MEMORANDUM

From:	Built Heritage Officer		
Service	Green Infrastructure	App No:	251049 + 251050
Address:	River Cottage, Church Street, Wargrave, RG10 8EP.		
Proposal:	251049: Householder application for the proposed part single storey, part two storey rear extension followed by external refurbishments, changes to fenestration and internal alterations to a listed building. 251050: Application for listed building consent for the proposed part single storey, part two storey rear extension followed by external refurbishments, changes to fenestration and internal alterations.		
Heritage Asset:	• River Cottage - grade II listed building, since 1983. • Mill Green House/Old Gaunt House – grade II listed building, since 1983. • Wargrave Conservation Area Listed Buildings and Conservation Areas are classed as designated heritage assets under the NPPF (2024) and in the Council's Local Plan policies.		
Site Visit Made:	Yes - for pre-app

- A) Extract of drawing PA014 Rev.01 – the corner return of the existing rear range and the boundary wall appears erroneous,
- B) Extract of drawing PA015 Rev.01
- C) Extract of Drawing PA018 Rev.01

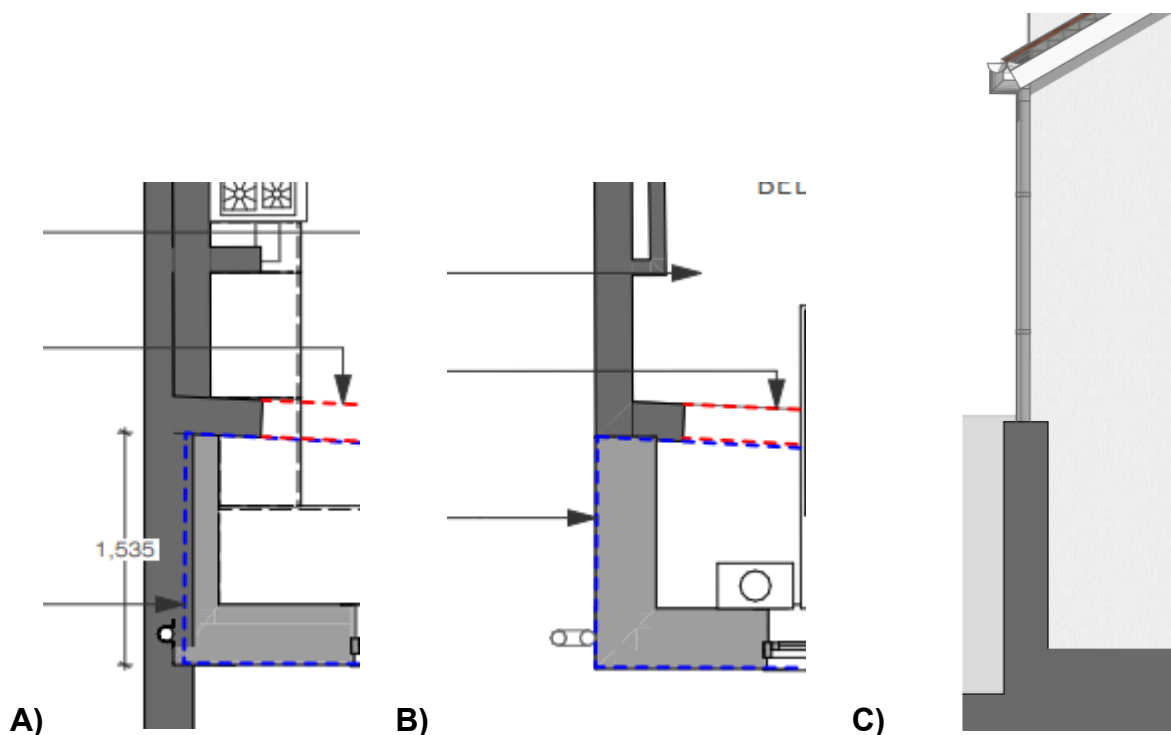
- There are 2no. new windows indicated for the proposed new rear bathroom, for which there are no joinery details.
- The brick boundary walling to the western side of River Cottage, which in part runs along the side elevation of the cottage, and which appear to be of a hick width to the rear. The ownership of this boundary wall is not stated and seemingly would belong to Old Gaunt Cottage, itself a listed building. The boundary walling may well hold curtilage listed status to Old Gaunt Cottage. Seemingly the proposed rear new two storey extension, for which there would be an apparent need for foundations, would require part of the boundary wall to be removed/rebuilt to do so. Also there is the question as to the routing of the rainwater downpipe that appears is intended to pass through the boundary wall. (see attached images below)

- a) A Schedule of works that sets out and identifies the works to be undertaken to repair the roof structure, including the ceiling joists of the first floor. Details shall identify all those elements to be repaired and/or replaced and set out the methodology for the repair works.
- b) A methodology statement/details that sets out how the for the new walling of the rear two-storey extension is be constructed along the boundary with Old Gaunt House. Details to also show how the rainwater downpipe would be routed to the ground.
